**CITY OF PORTLAND, MAINE  
DEVELOPMENT REVIEW APPLICATION  
PLANNING DEPARTMENT PROCESSING FORM  
Planning Department Copy**

**04/27/1999**  
Application Date  
**Forest Avenue - 295**  
Project Name/Description

**295 - 295 Forest Ave, Hannaford Bros**  
Address of Proposed Site  
**034A C001**  
Assessor's Reference: Chart-Block-Lot

This letter is to confirm the revision to the approved plan of the Shop 'N Save project located at 295 Forest Avenue. The approved revision includes the substitution of a Vortech stormwater treatment tank with a HIL Technology stormwater treatment tank. The revised plan has been reviewed and approved by the project review staff including representatives of the Planning, Public Works, Building Inspections, Fire and Parks Departments.

**Conclusion:**

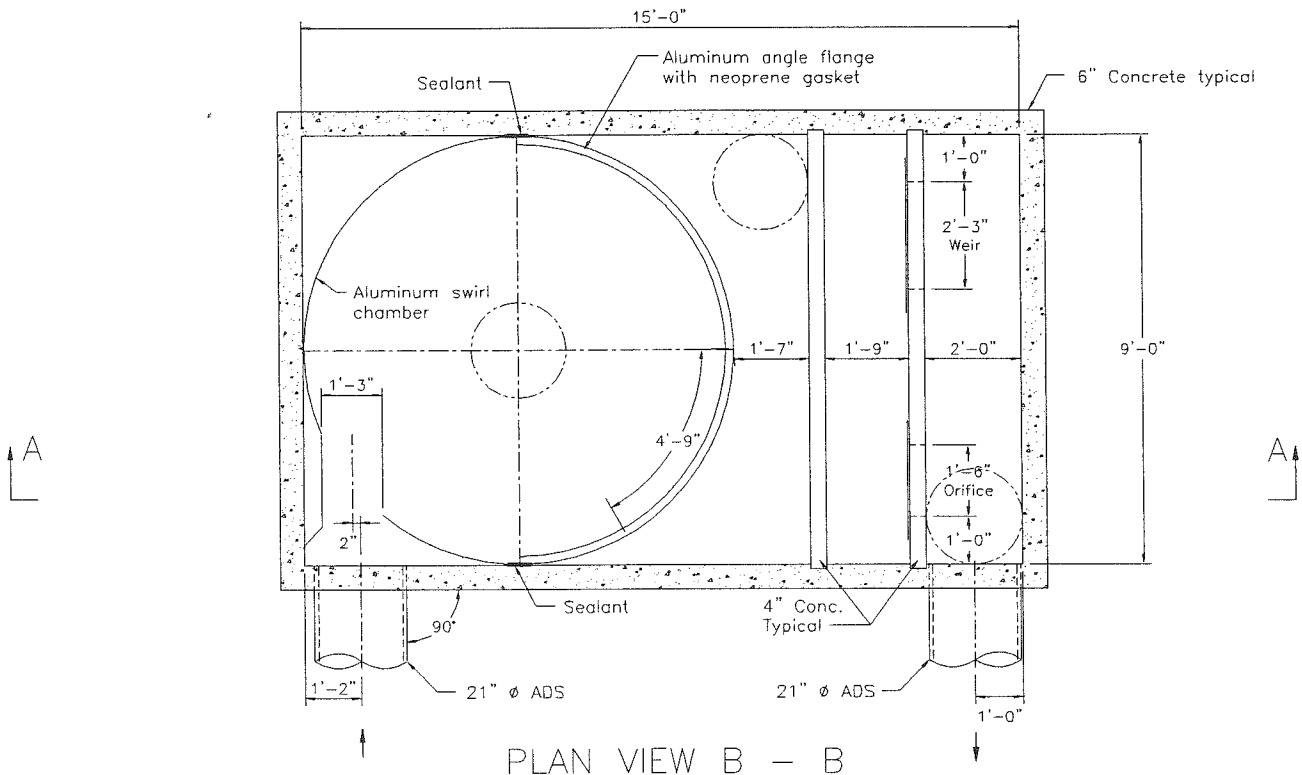
Item 3: Enclosed is a sheet of bypass calculations used in determining the design of the external bypass upstream of the Vortechs Model 9000. Based on the 25-year design storm of 23.74 cfs, the 100-yr flow was estimated as 29.7 cfs. The height of the bypass wall was calculated such that in the estimated 100-yr flow, 15.7 cfs will be bypassed and 14 cfs will be treated through the Vortechs Model 9000. In that the Vortechs Model 9000 has a treatment capacity of 14.0 cfs, the maximum flow through the Vortechs System will not exceed this capacity as discussed. Technical Bulletin #3A is also enclosed as a further explanation of the bypass design.

**The bypass weir crest should be set at an elevation of 97 ft with a length of 5 ft.**

SECTION A - A

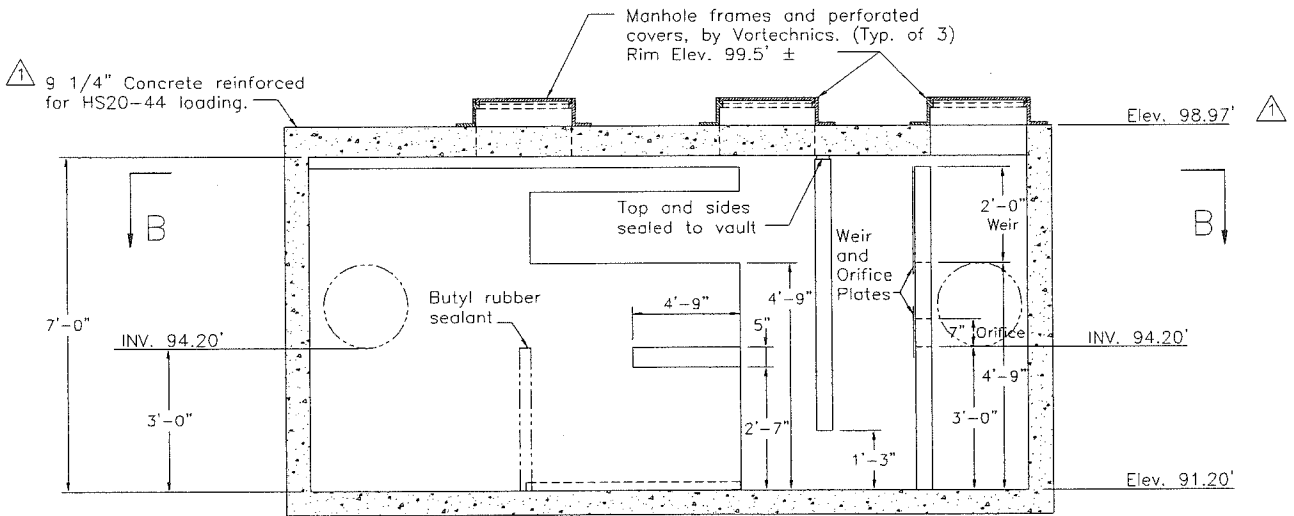
Item 4: Enclosed is a design detail of the proposed Vortechs Model 9000. In the 25-year storm event, the maximum velocities in the system will occur under the baffle wall. As discussed previously, the 25-year flow through the Vortechs System will not exceed 14 cfs. Therefore, calculating the opening under the baffled wall as 9 ft X 1.25 ft = 11.25 sf, the maximum velocity in the system will be 14 cfs / 11.25 ft = 1.24 fps.

MODIFIED SITE PLAN  
GENERAL ARRANGEMENT  
(DIMENSIONS, HYDRAULIC PARAMETERS,  
COMPONENTS, MATERIALS LIST)  
PLAN VIEW  
SECTION VIEW

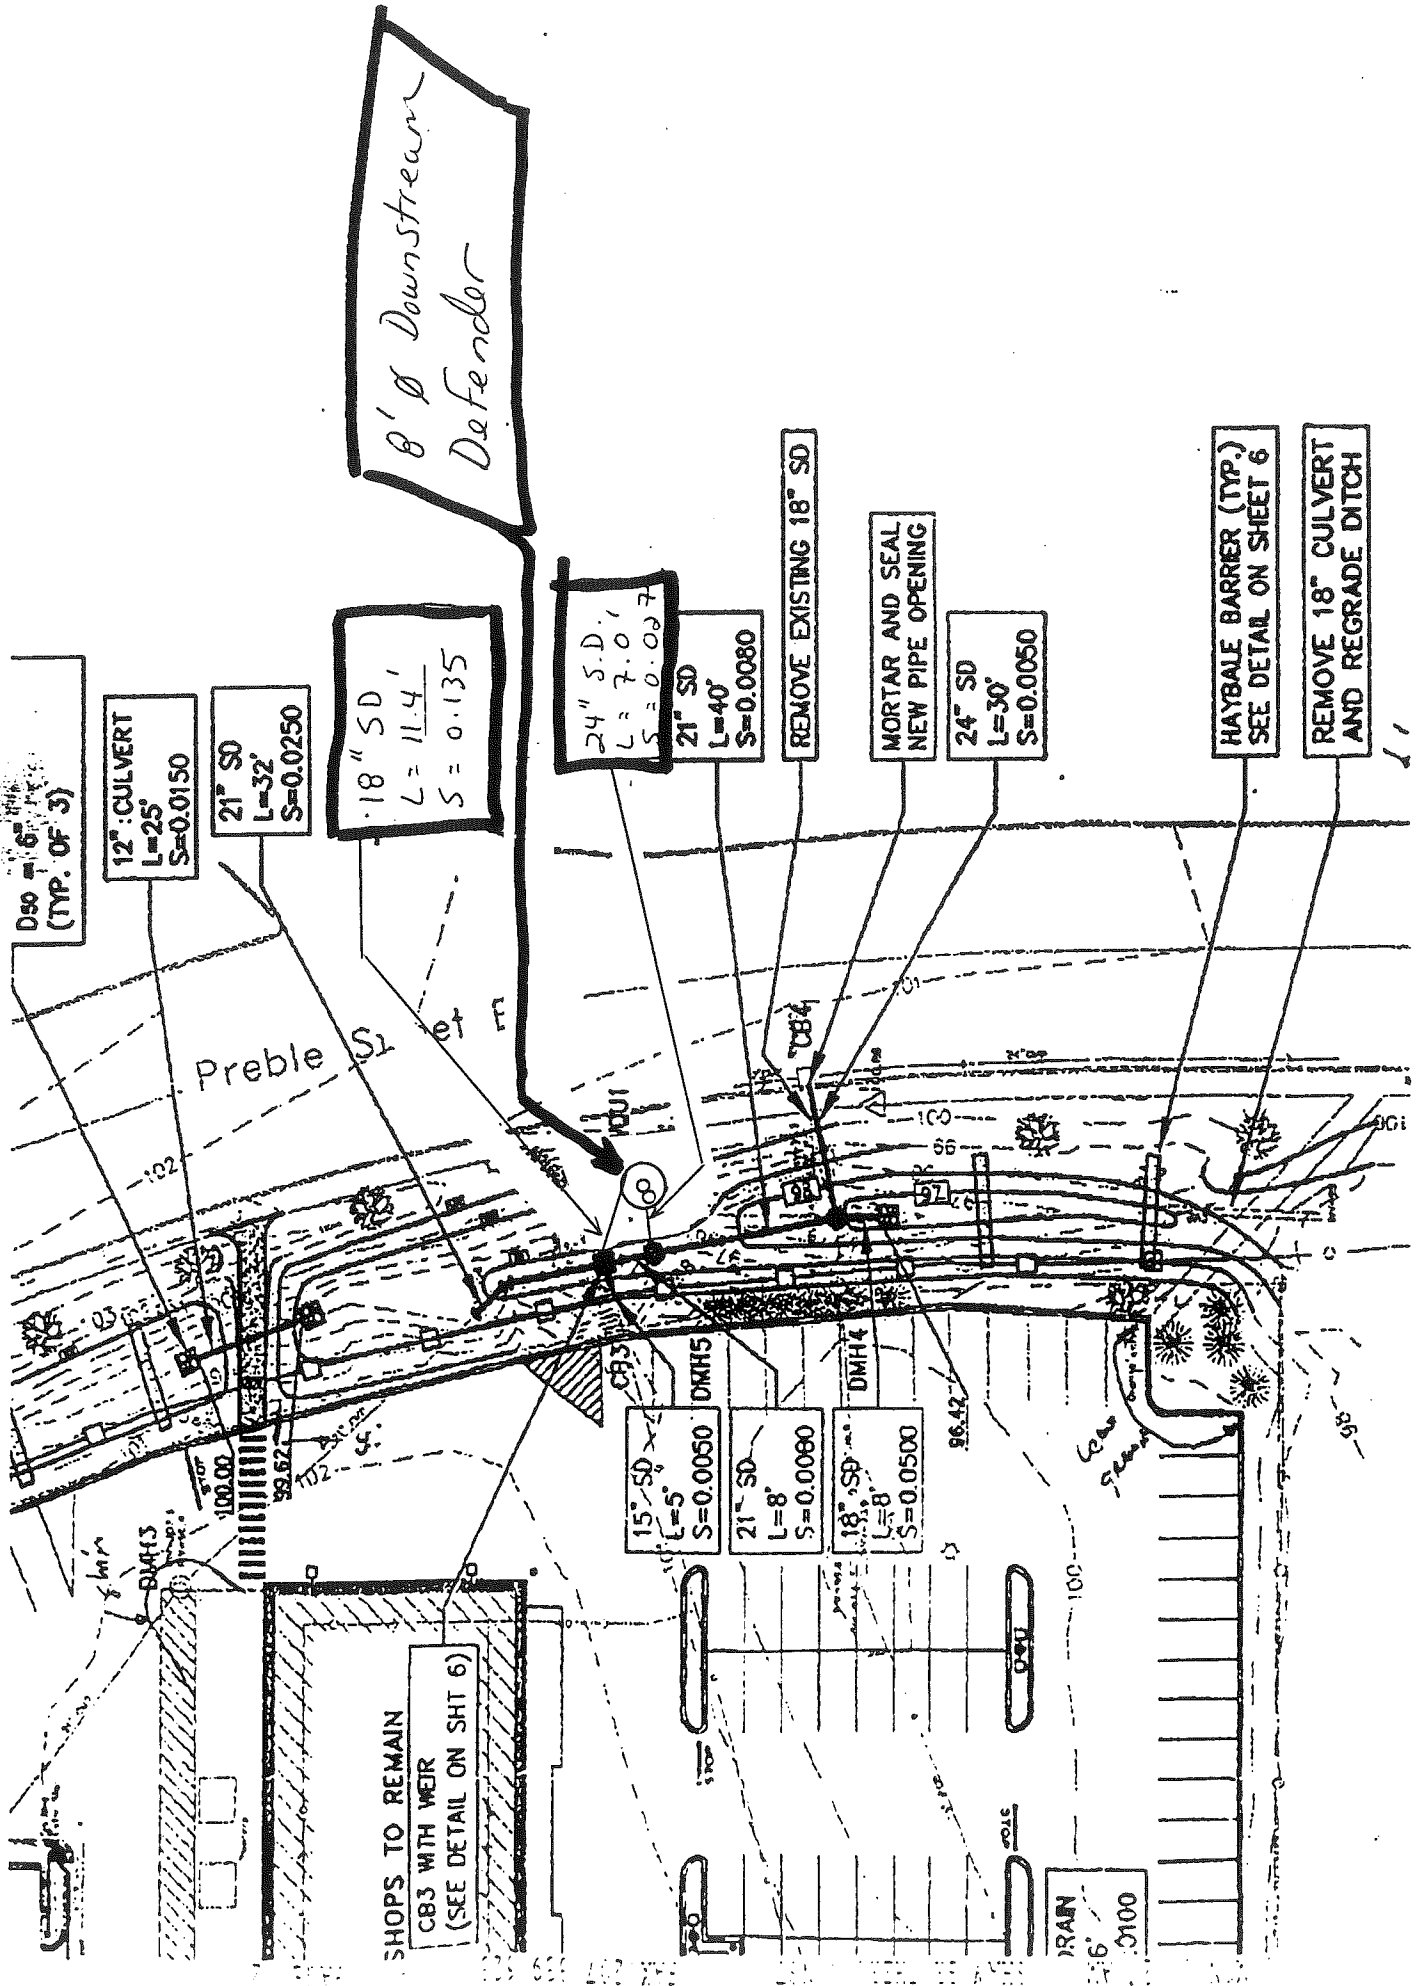
Please refer to drawing GA2 and the marked up photocopy of the site plan.

We have proposed placing an 8-ft dia. Defender approximately 6' o.d to o.d on the Preble St. Ext. side of DMH5. We have configured the system so that the Defender's overflow pipe will enter DMH5 approximately perpendicular to the 21" storm main. Similar to the Vortechs proposal, a weir wall with an effective length of 5 feet in CB3 would divert flow to the Defender for treatment. **It is very important that the contractor notify H.I.L. Technology as soon as possible if separator system cannot be laid out as shown by the enclosed shop drawings. The drawings can be modified accordingly to ensure that the Defender is fabricated to fit the location properly.** Apart from the location of the unit, we have also made a few minor recommendations that we would like to make you aware of:

- As an 8-ft Defender has a standard 24" overflow pipe stub, we have proposed running a 24" pipe rather than 21" pipe from the Defender to DMH5.
- Please note that as a result of locating the Defender adjacent to DMH5, CB3 will need to be modified to accommodate the proposed 18" pipe running to the Defender. (The angle of entry will be different than the angle shown by the 6'-0" catch basin detail shown on sheet 6 of the site plan.)

CAD Ref:	8GA1A
Wipe No.	2000/297
Drawing No.	GA1
Rev.

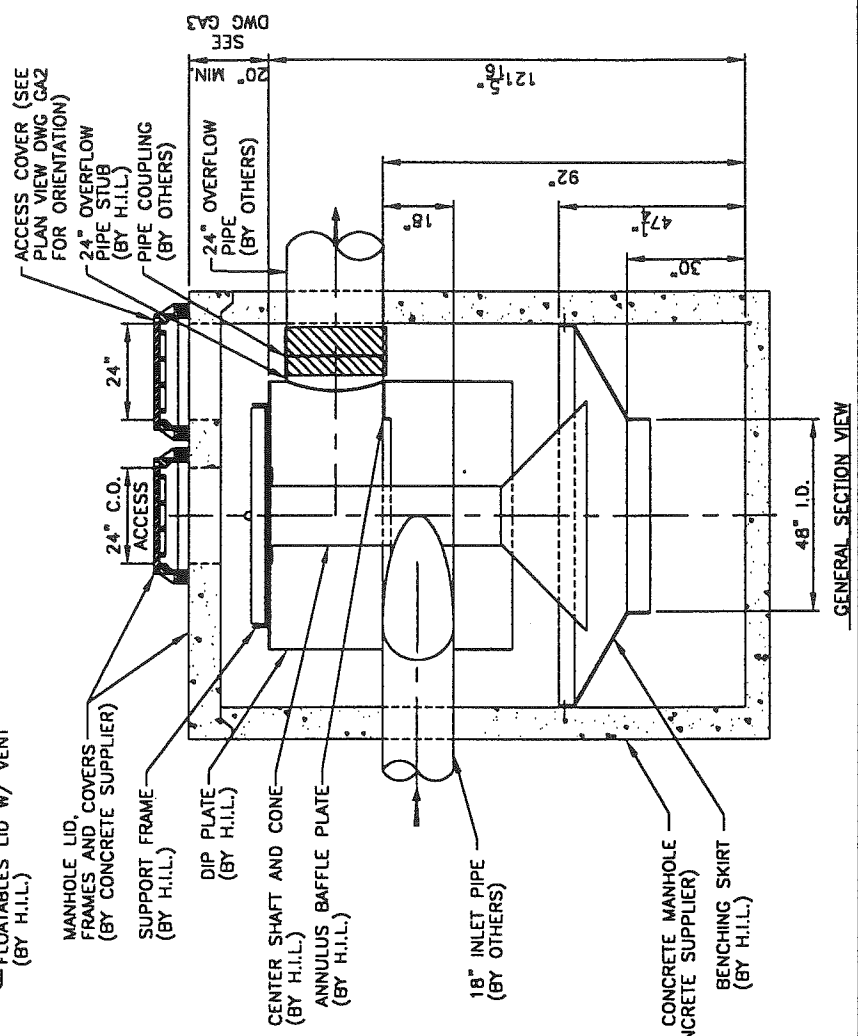
The treatment volume for each size Downstream Defender is defined as the space between the top of the sloping part of the benching skirt and the invert of the outlet pipe. See general arrangement drawing GA1.
